Re: Boulger Dam / UT00695 - Skyline Subsidence Memorandum (April 21, 2017)

Mine 4
Mine Plan
2017

Canyon Fuel Company, LLC
Skyline Mines

DWG. NO.: 3.1.8-3(2017)

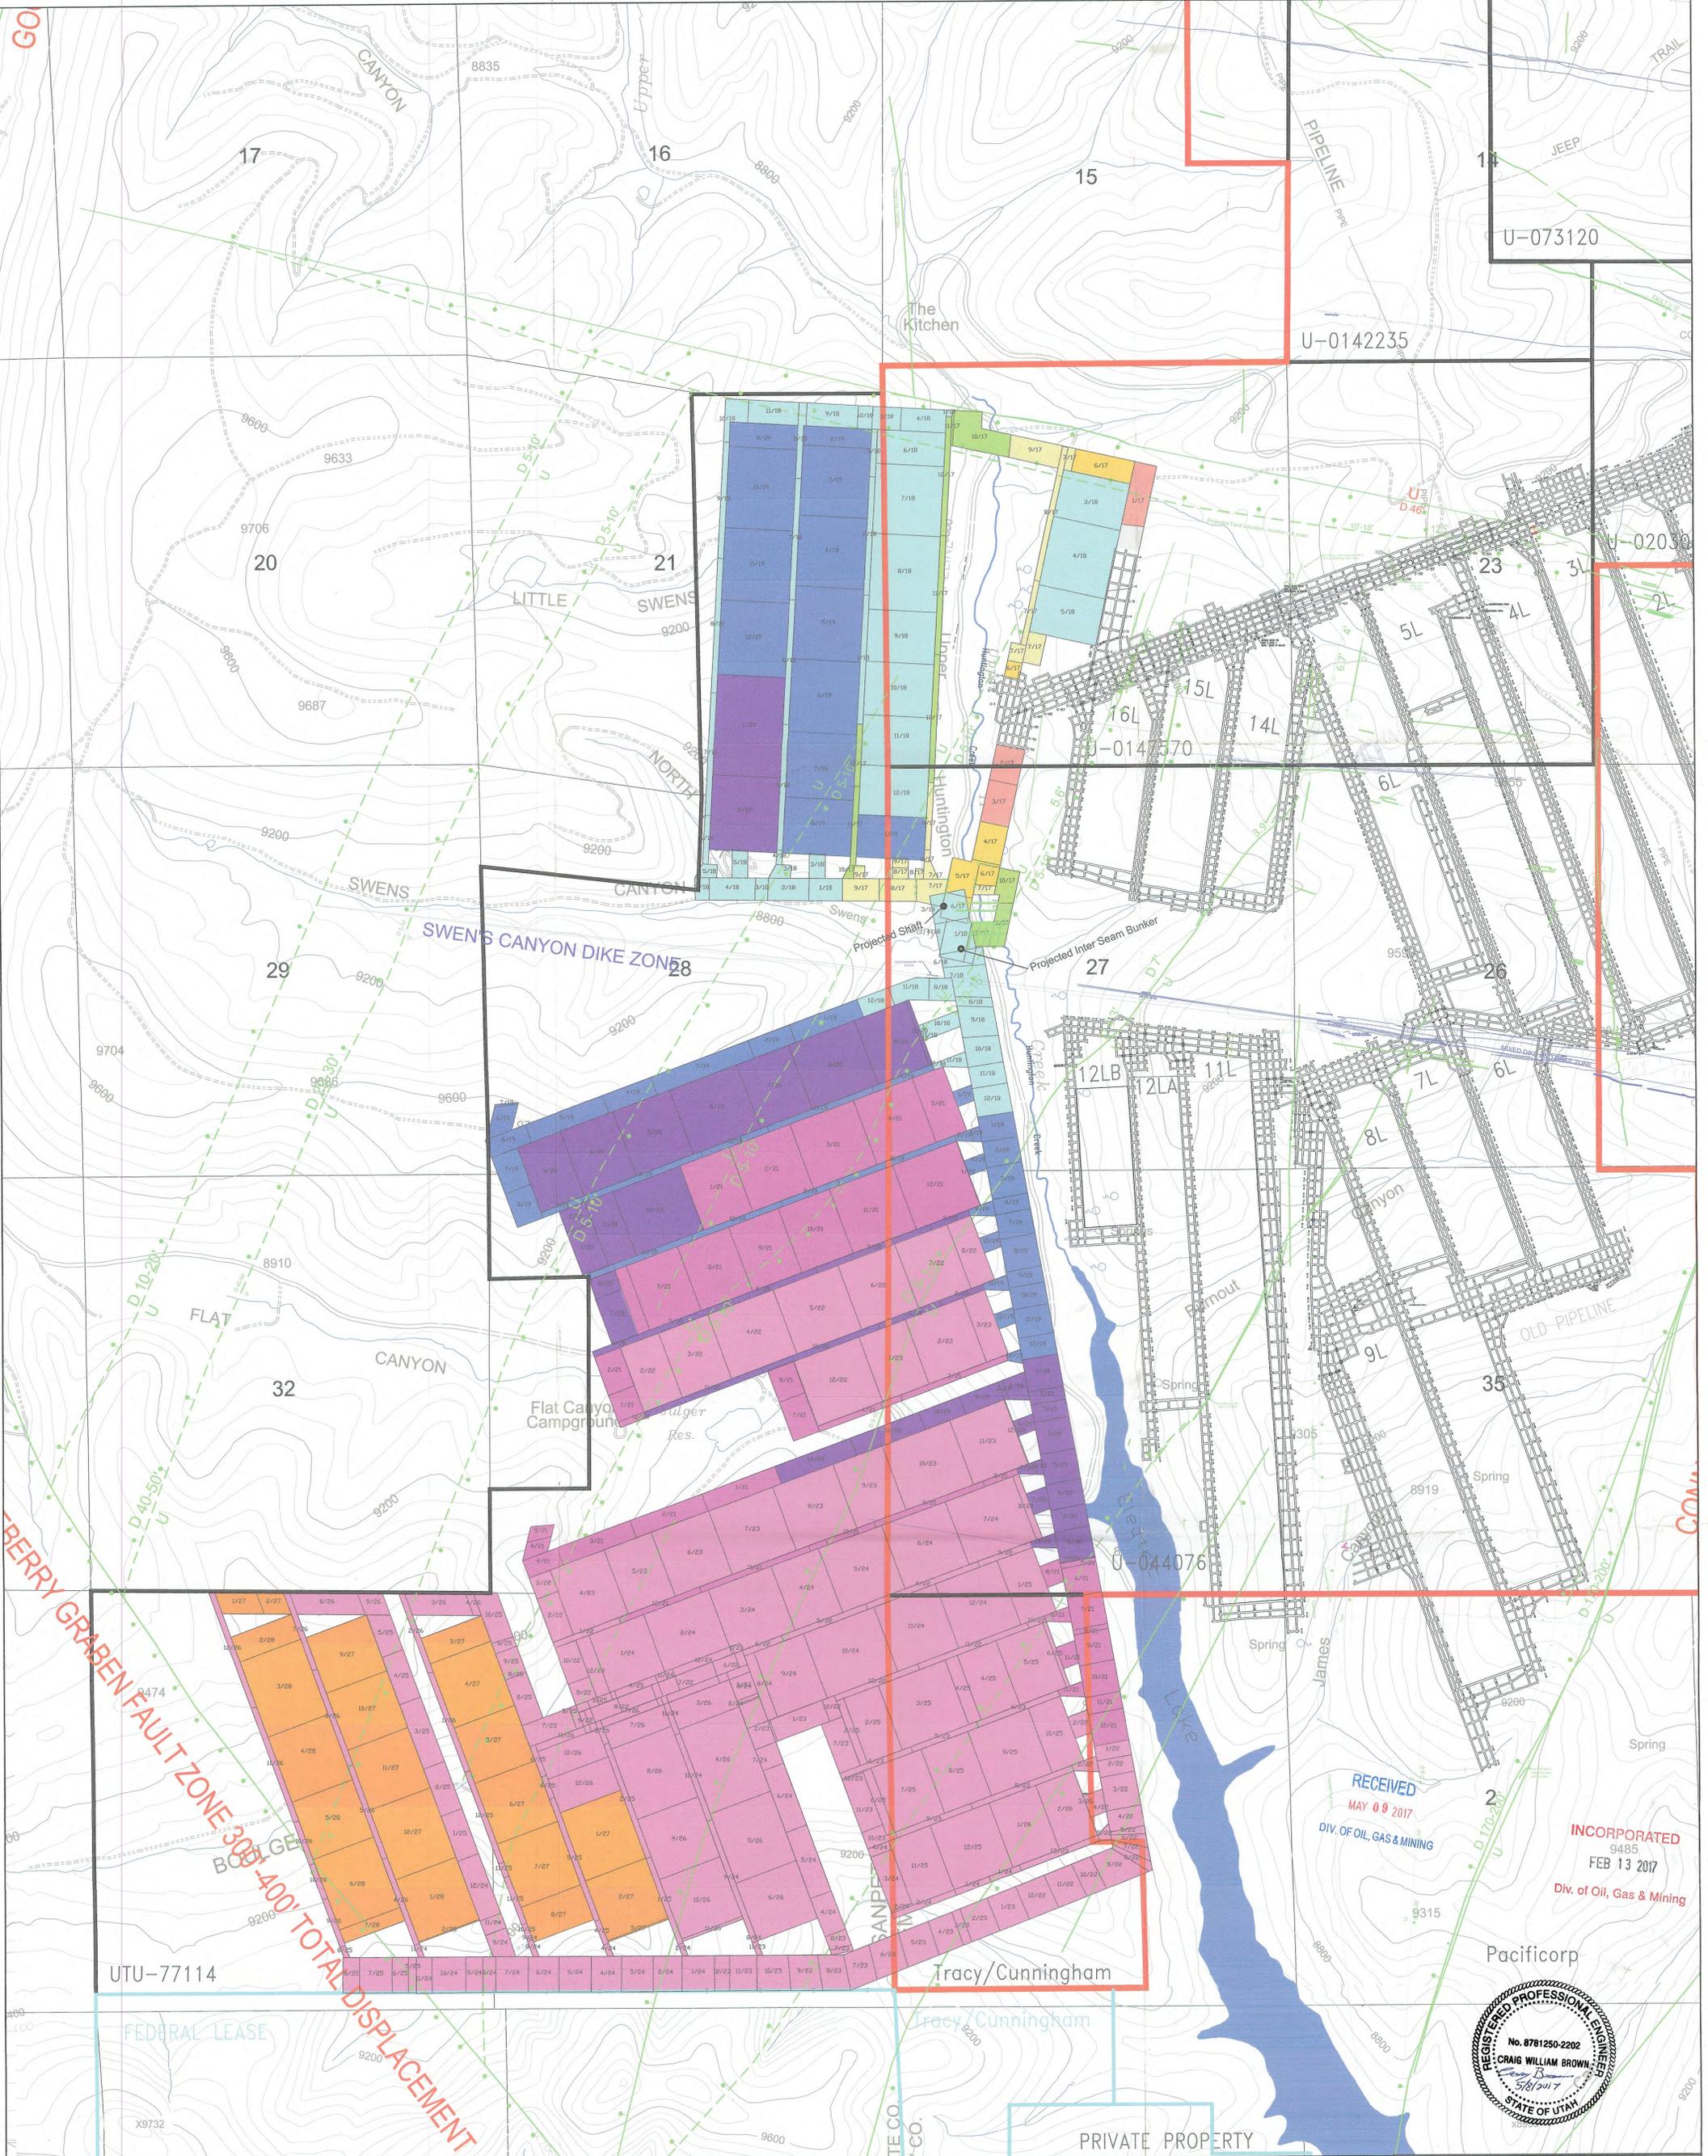
Per our conversation earlier this morning, I've attached Plate 3.1.8-2 . The plate depicts the mine plan that was recently approved as part of the Flat Canyon Lease addition. Once you've had a chance to review it, let us know what your finding is relative to the Boulger Reservoir monitoring that Skyline discussed in it's April 2017 memorandum.

It is noted that the panel layout and location as shown in the April 2017 memorandum is different from what Dana Dean originally sent to our office in February 2017. The layout that Dana sent shows the south panel about 250-feet away from the dam, while the April 2017 memorandum shows the south panel shifted further to the south and about 750-feet away from the dam. We're assuming that the layout shown in the April 2017 memorandum is the correct layout. Please verify.

As far as follow-up items, the one that comes to mind is the statement that the Boulger dam will be instrumented to monitor mining-induced seismicity. As identified within the April 2017 memorandum, this monitoring will need to be initiated well before any mining takes place in close proximity to the Boulger dam. The April 2017 memorandum also identifies that a comprehensive risk analysis will be performed "to determine whether additional monitoring should be conducted to insure the integrity of the Boulder Reservoir Dam." We look forward to receiving a copy of this risk analysis.
